PERRY NUCLEAR POWER PLANT PROJECT ORGANIZATION
CEI NUCLEAR ENGINEERING DEPARTMENT
AND KAISER ENGINEERS, INC.

July 24, 1981

Re: MEB SER

Attached is our preliminary response to open items identified in the Draft MEB SER for sections 3.2, 3.6, 3.7, and 3.9. These responses will be used as a starting point for our August 4 meeting.

PERRY NUCLEAR POWER PLANT THE CLEVELAND ELECTRIC ILLUMINATING COMPANY
	Steam Tunnel Arrangement Figure 10-3-1

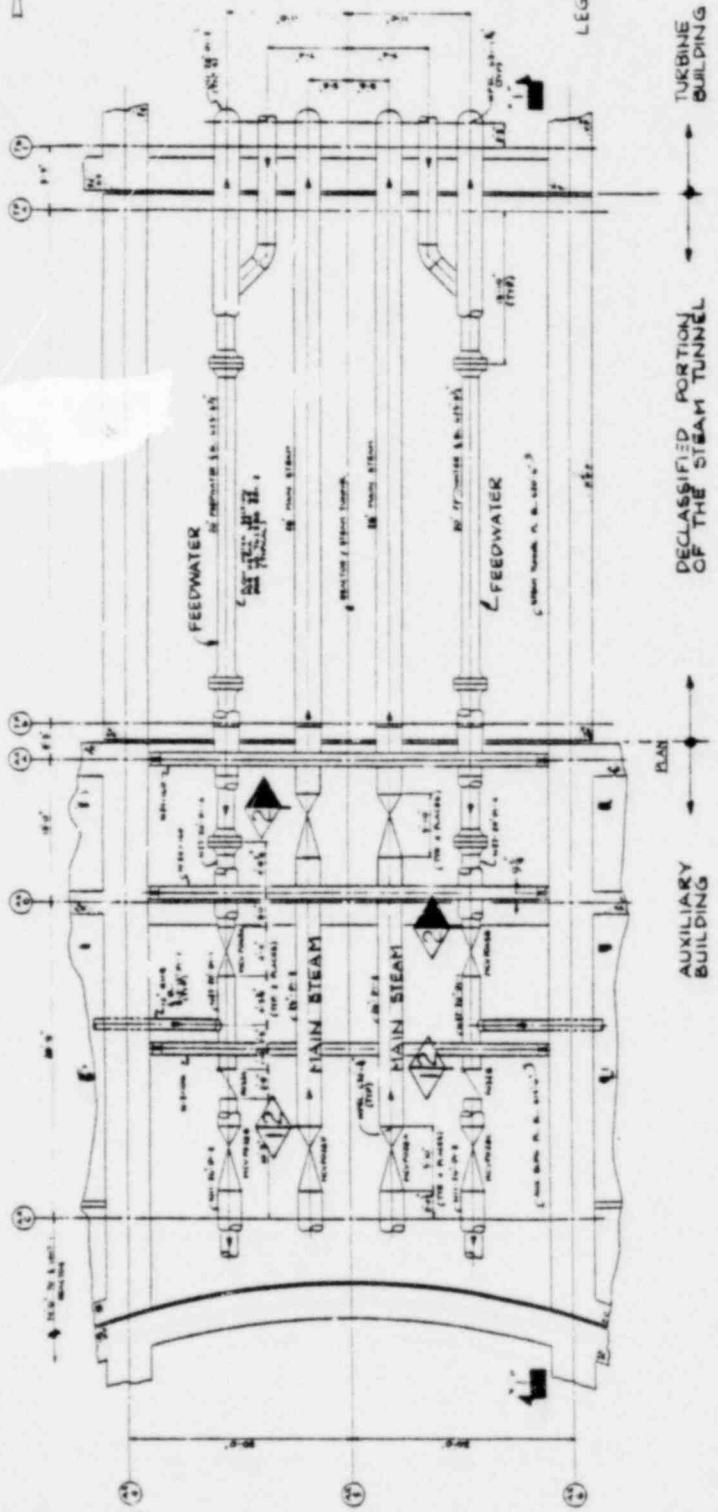
DSER 3.2-8 There appears to be a discrepancy in the seismic classification of
(Table the discharge tunnel. The discharge tunnel and the diffuser
3.2-1, nozzle are Seismic Category I. The tunnel entrance structure and
Page 3.2-24) downshaft are not. Provide clarification for this apparent
 contradiction.

A length of 4'-8-3/8" of main steam piping is located in the Auxiliary Building.
Refer to revised Figure 10.3-1.

Figure 3.6-5
 (GAI Desg. D-303-605)

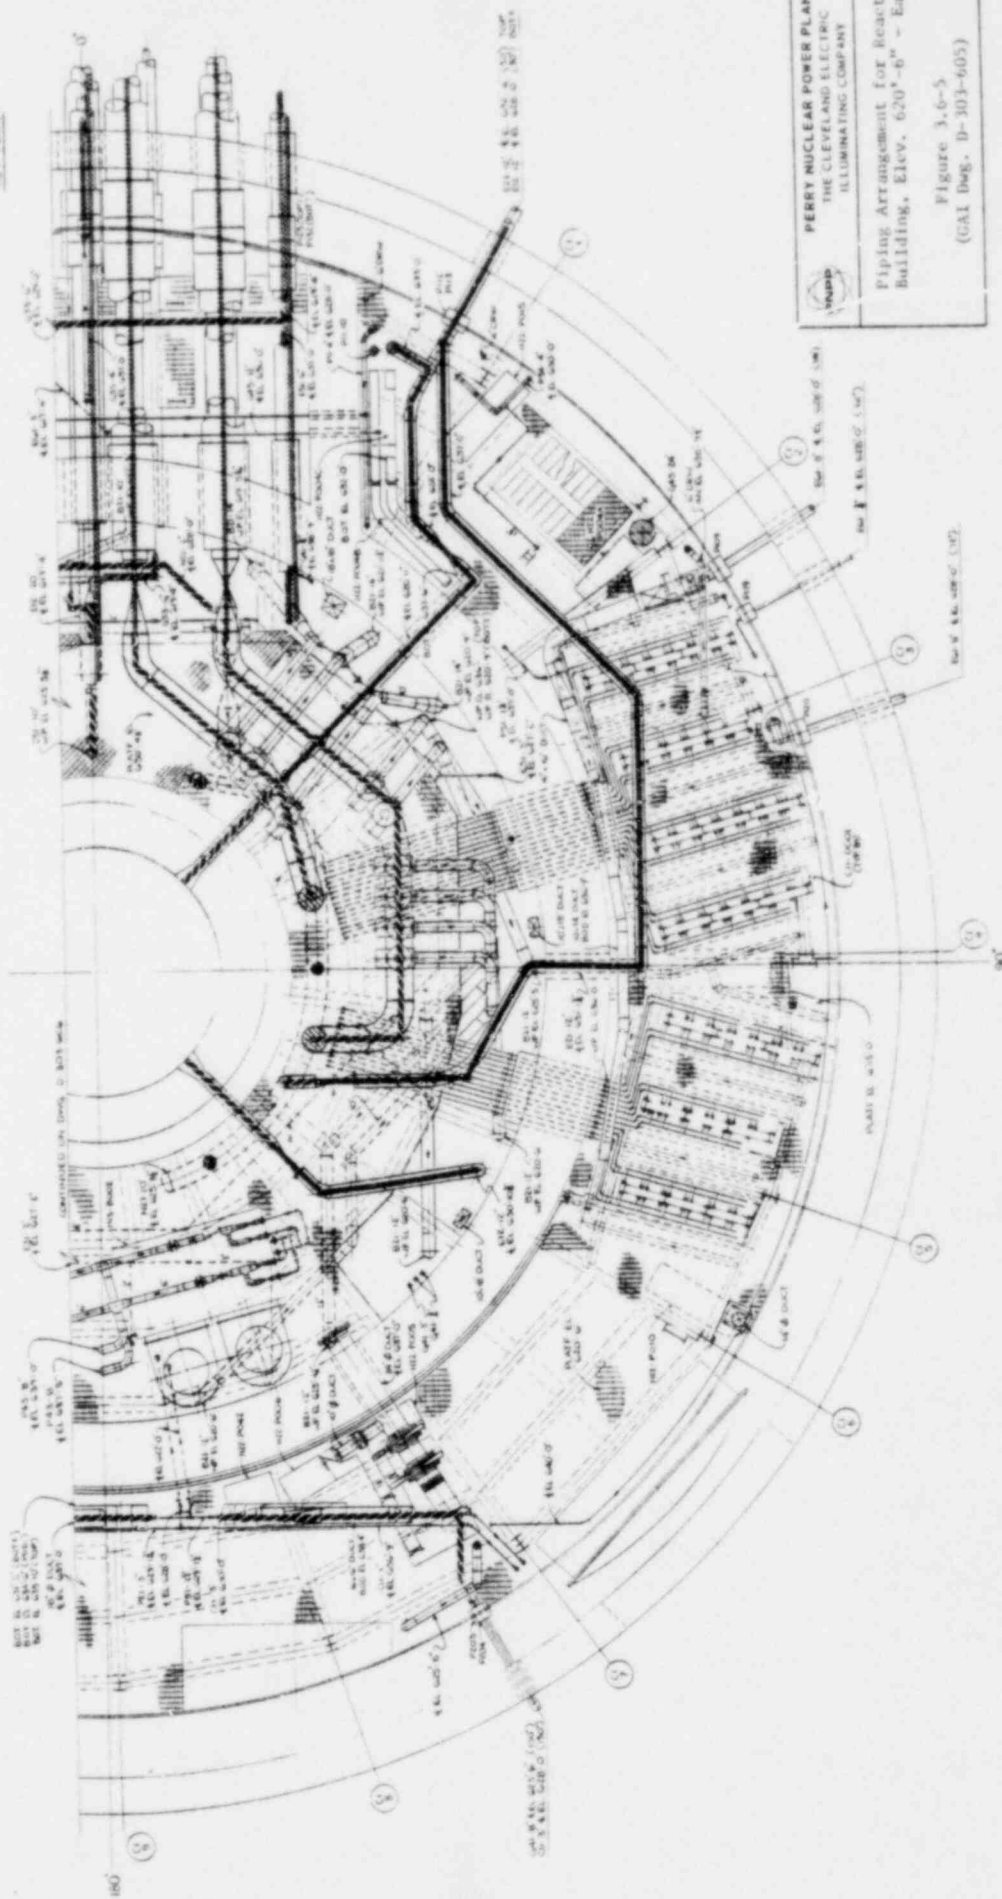
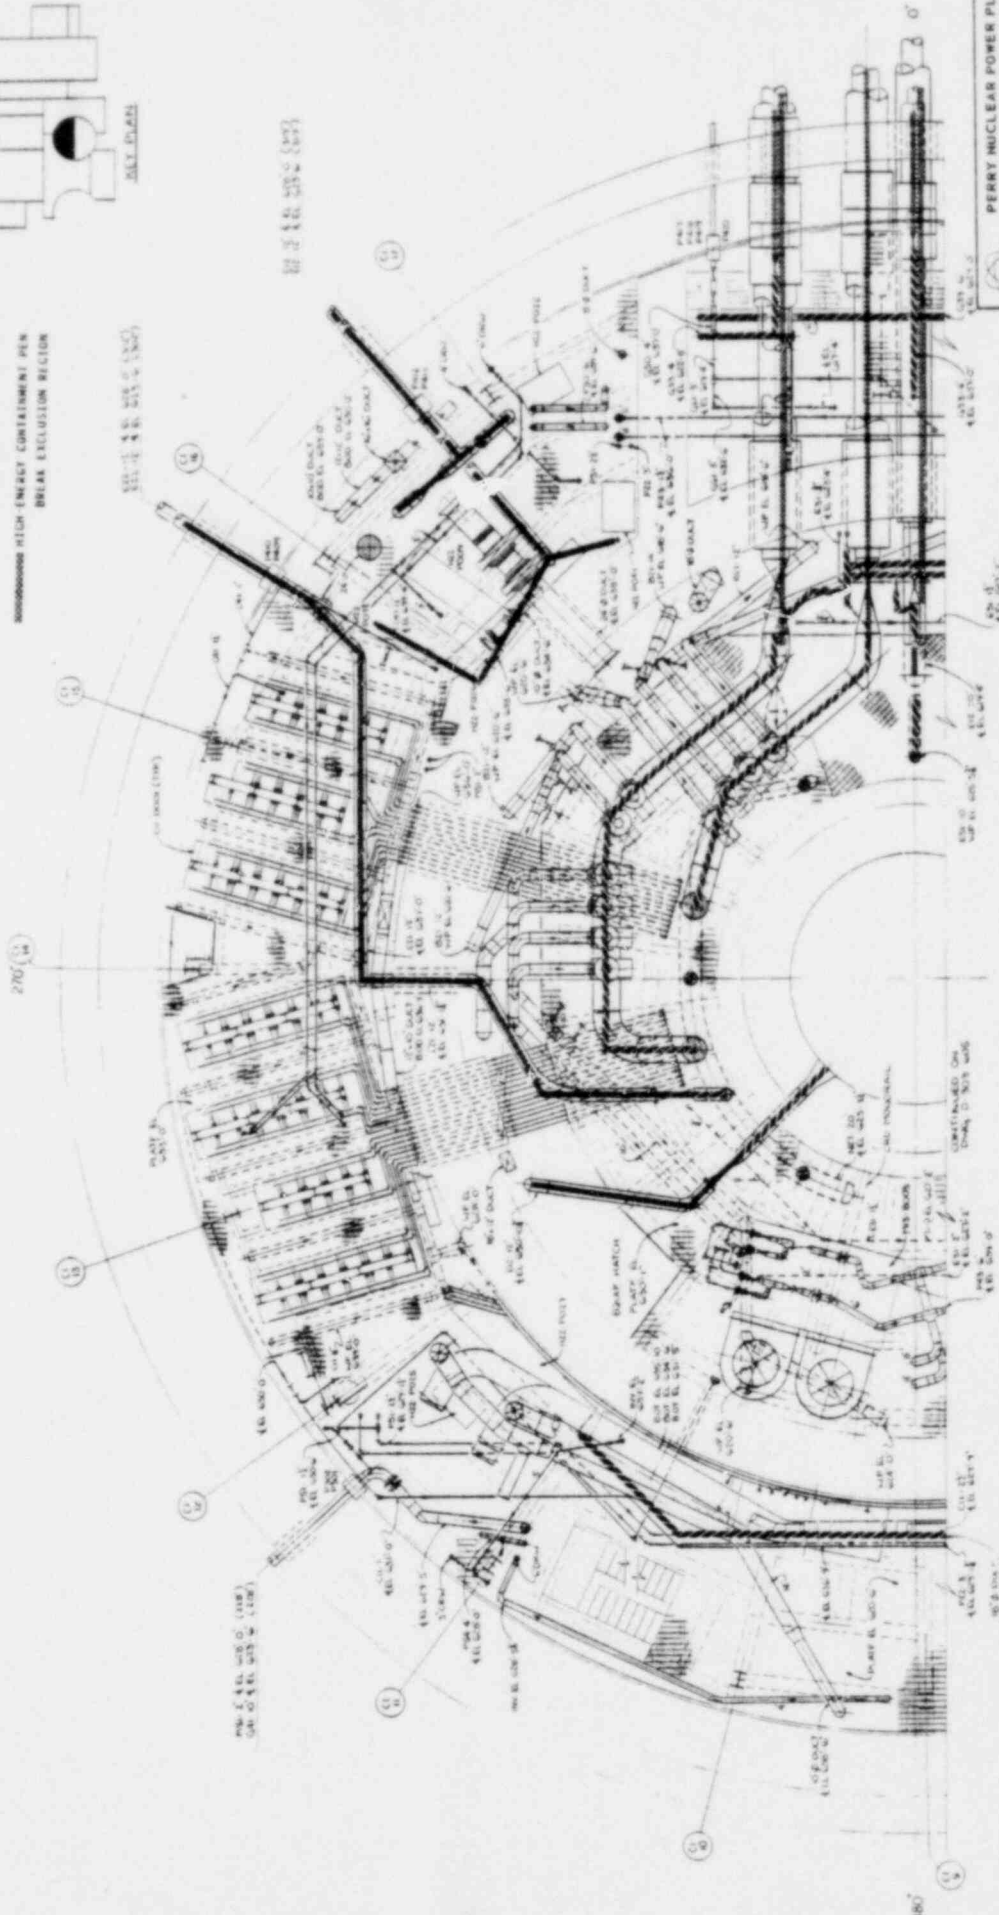
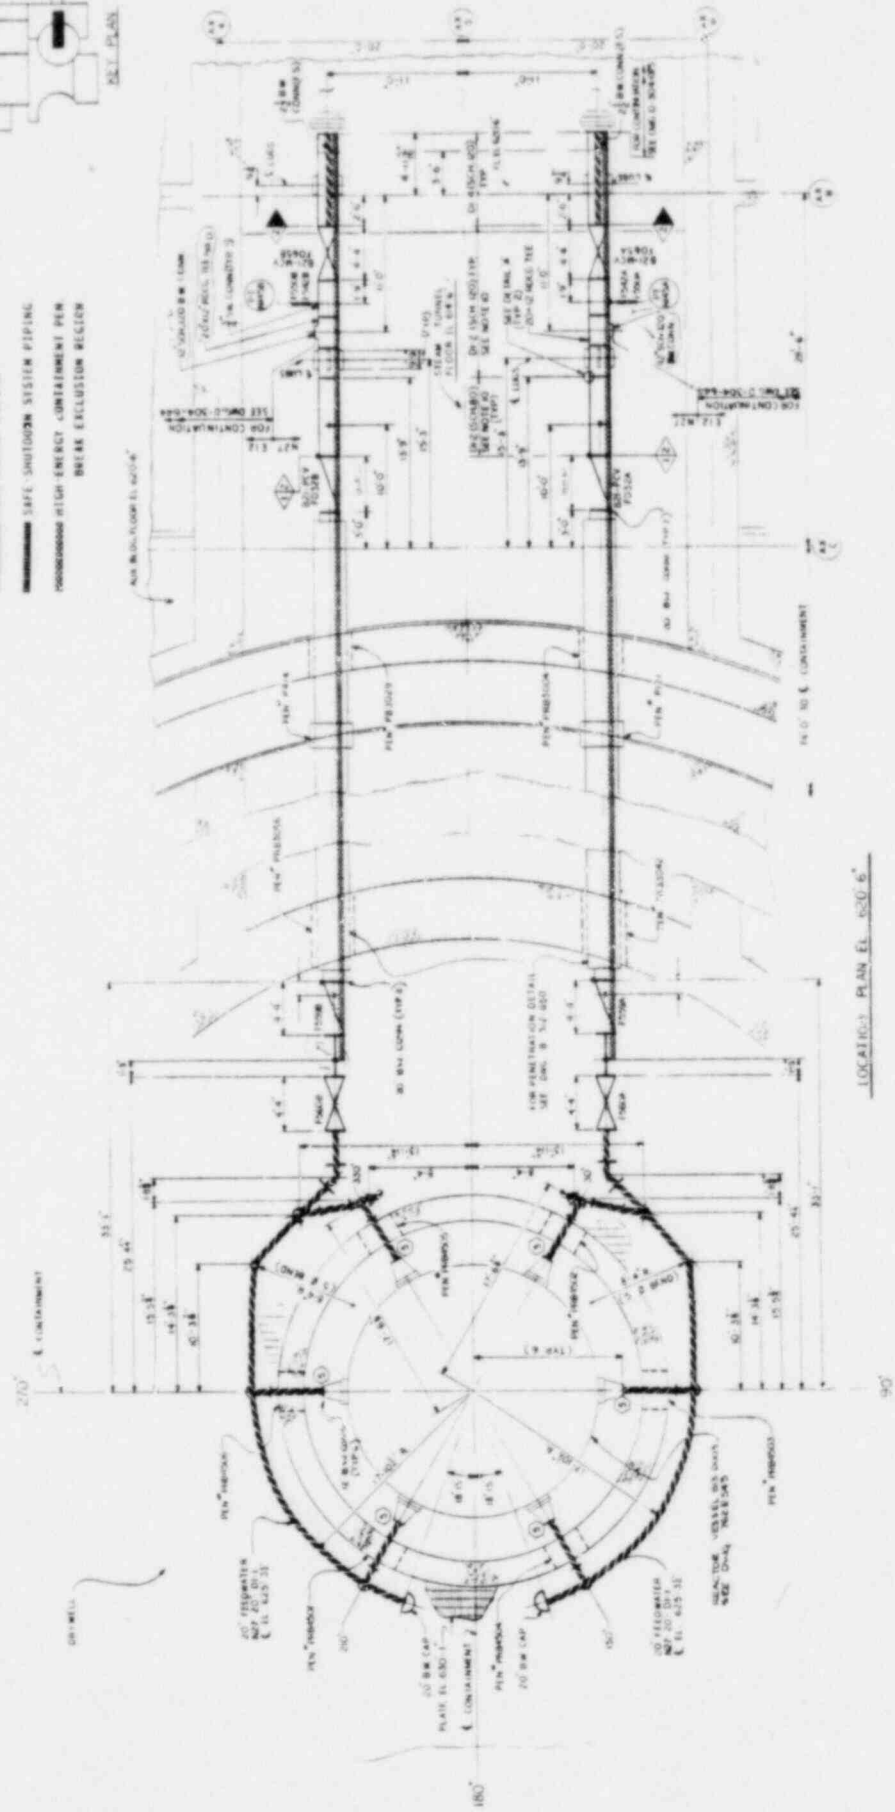
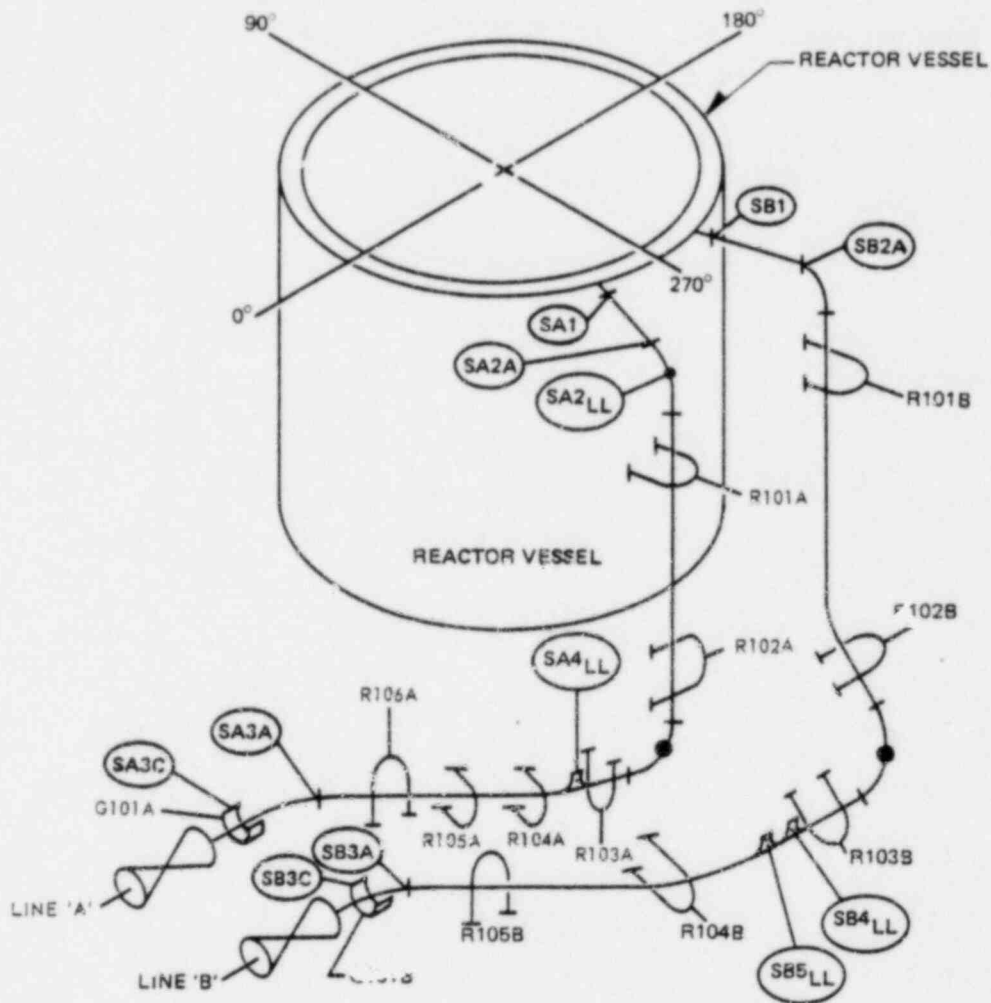
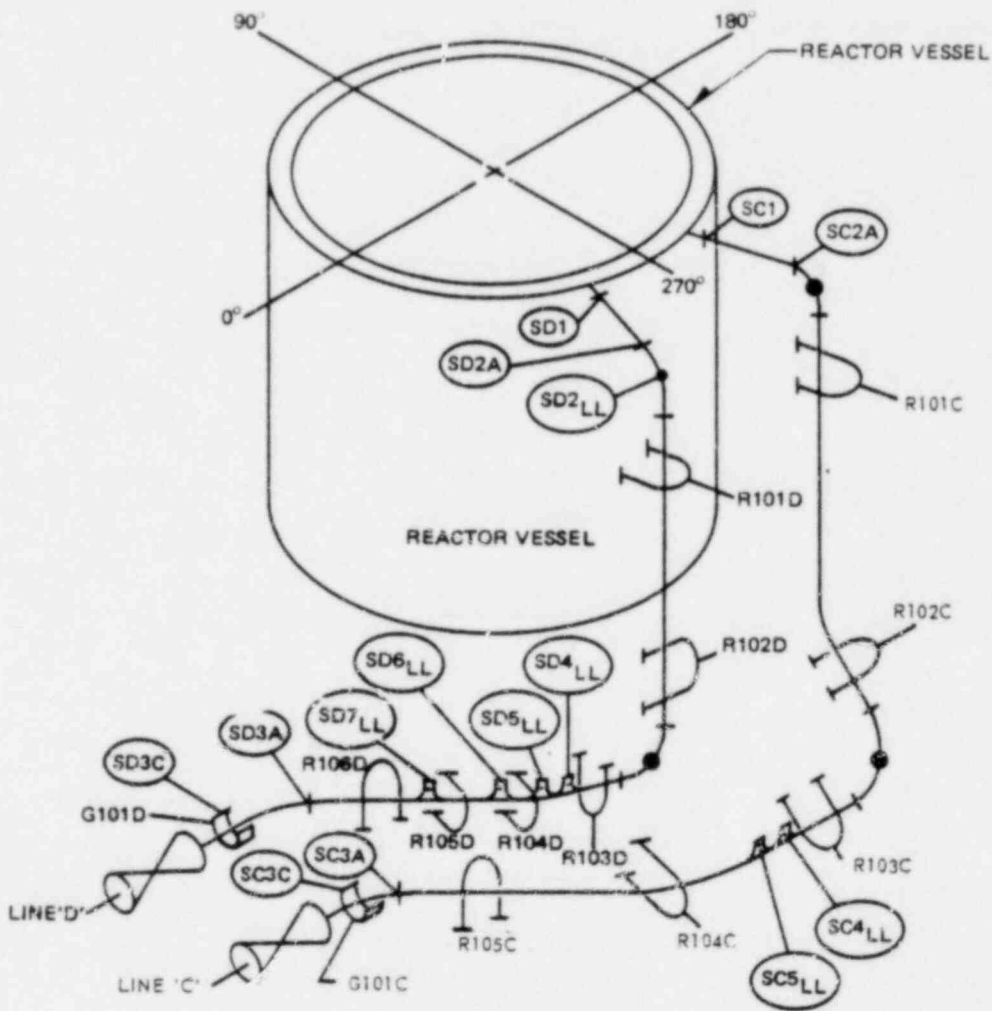
Response

The response to this question is provided in revised Section 3.6.2.1.7.1 and Figures 3.6-5, 3.6-6 and 3.6-7.

PERRY NUCLEAR POWER PLANT THE CLEVELAND ELECTRIC ILLUMINATING COMPANY
	Recirculation System Piping Postulated Break Locations and Restraint Locations Figure 3.6-66

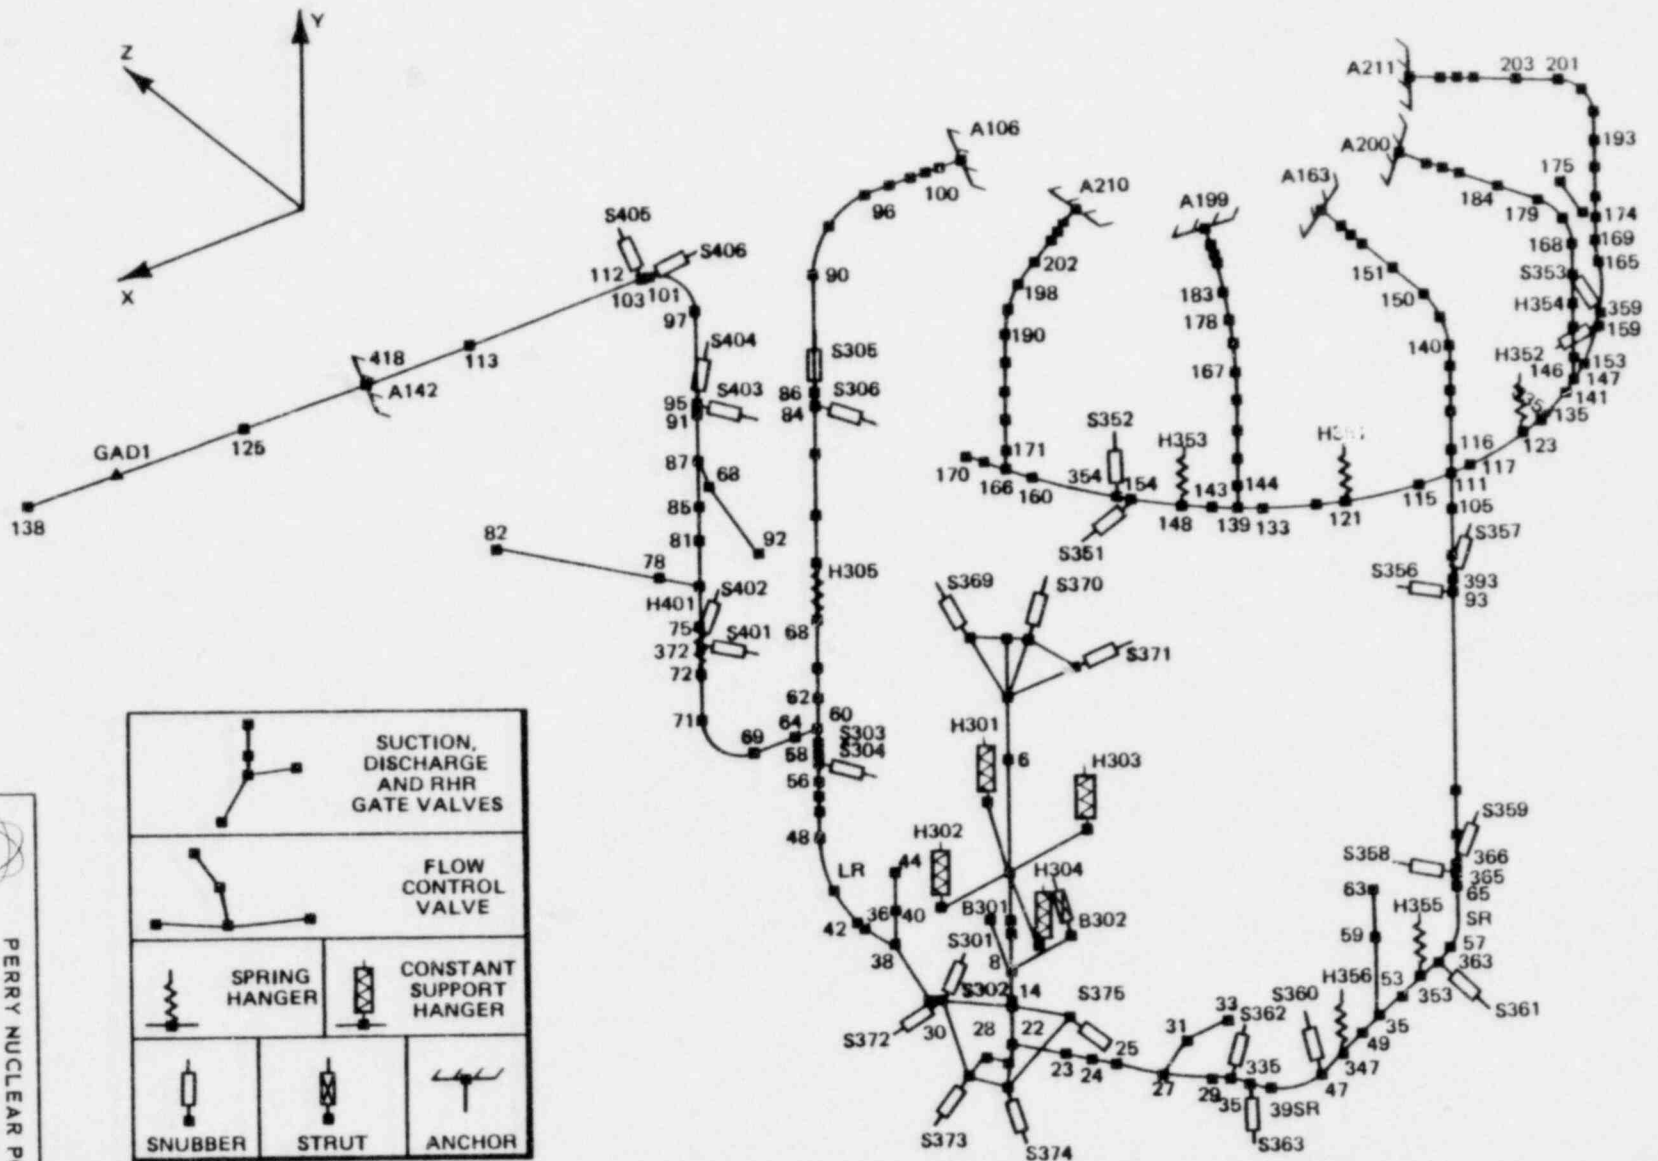
DSER 3.6-28 Are all postulated break locations in the recirculation system
(3.6.2, shown?
Figure 3.6-66)

All postulated break locations are shown on revised Figure 3.6-66, as determined by the final ASME Code stress analysis (General Electric document 22A7140, Rev. 0).
